Re: Greenfield Wastewater Utility – Waterview Lift Station Relocation Project

CONTRACT CHANGE ORDER NO.: No. 5

PROJECT NAME: Waterview Lift Station Relocation Project

WORK DIRECTIVE CHANGE NO.: 5

C-201

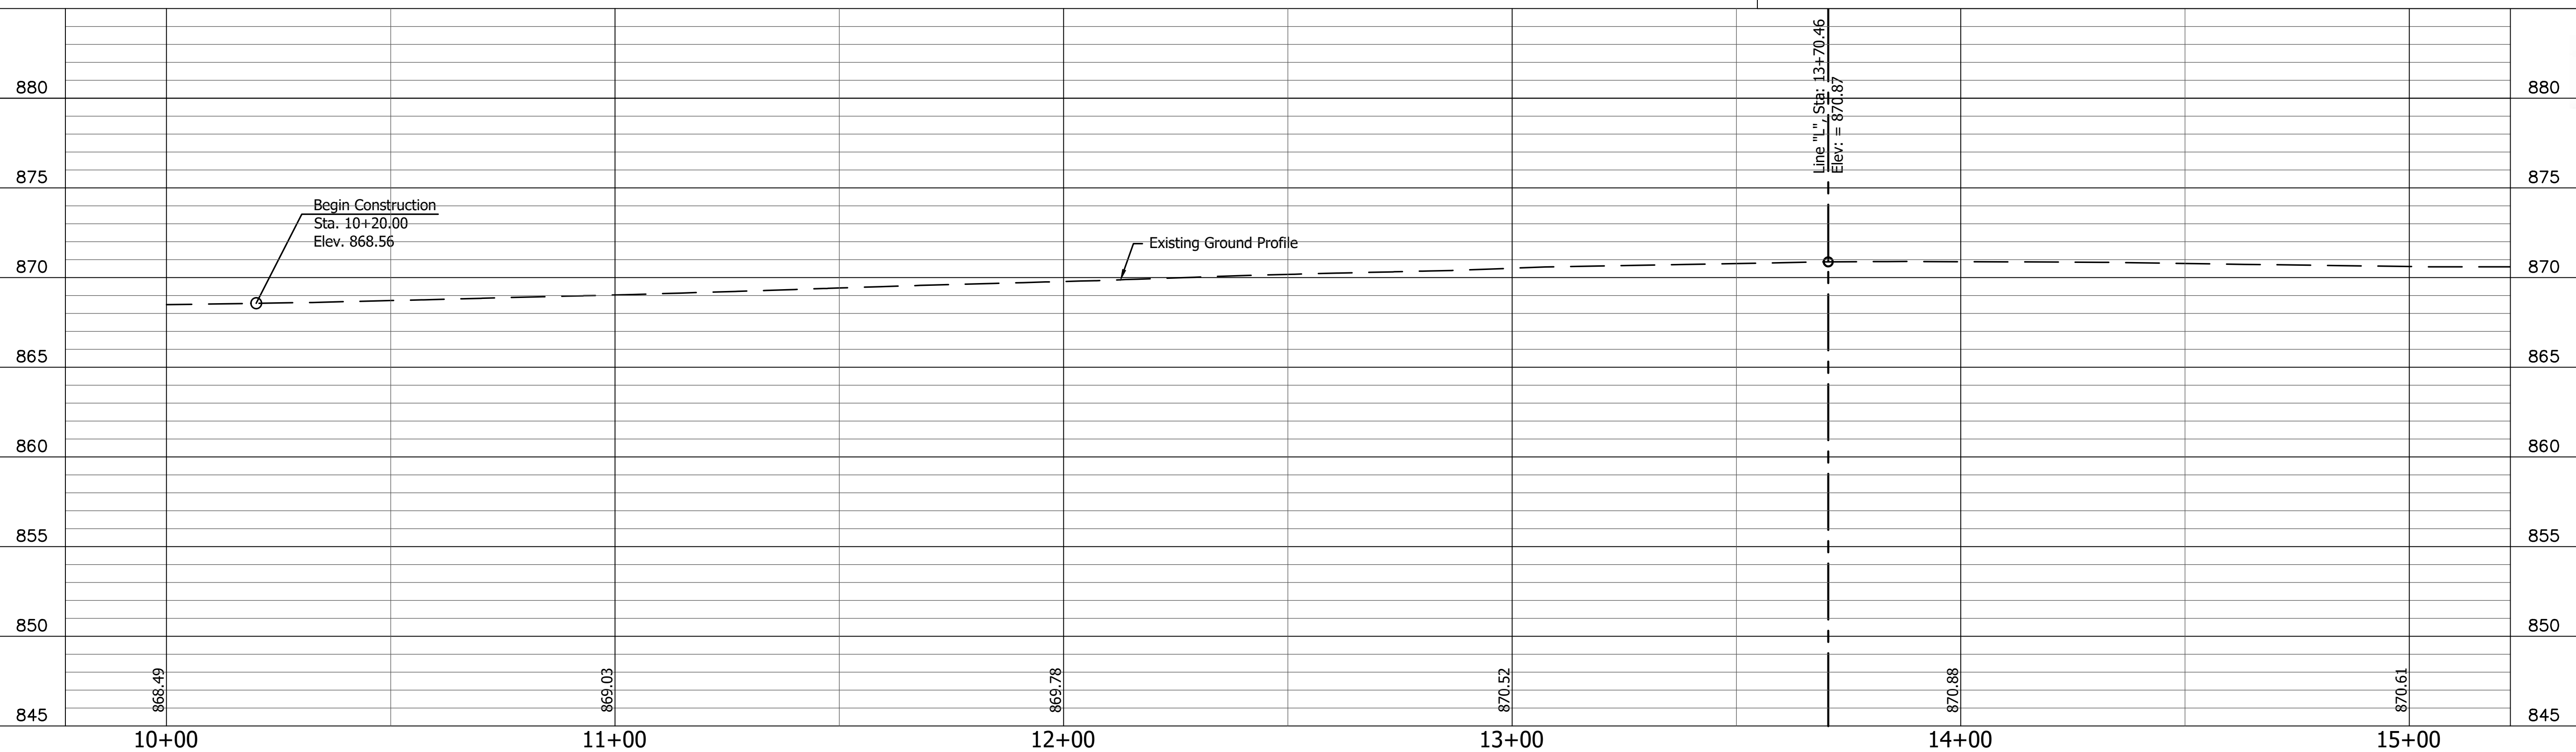
1. Remove 43 LFT of existing asphalt-covered sidewalk at 580 Waterview Blvd. Use existing pay item (0036) - Area = 19.1 SYS at \$19/SYS = \$362.90.
2. Replace 43 LFT of sidewalk at 580 Waterview Blvd. Use existing pay item (0035) - Area = 19.1 SYS at \$131/SYS = \$2502.10.

1. The homeowner at 580 Waterview Blvd. has paved asphalt over the existing concrete sidewalk and drive approach. During the Waterview Lift Station project, the contractor will replace the asphalt with concrete from the back of sidewalk to the back of the new roll curb. The existing asphalt shall be sawcut at the back of proposed sidewalk and new sidewalk shall match grade of the existing asphalt driveway. The contractor will place 8-foot ramps on both sides of the driveway to connect to the existing sound concrete sidewalks.

THIS WORK DIRECTIVE CHANGE AUTHORIZES THE WORK TO BE COMPLETED AS OUTLINED. A Contract Change Order for an additional 19.1 SYS of sidewalk and sidewalk removal at 580 Waterview Blvd. as directed by the City of Greenfield. Total cost is estimated at \$2,865.00 and would be offset by the construction contingency.
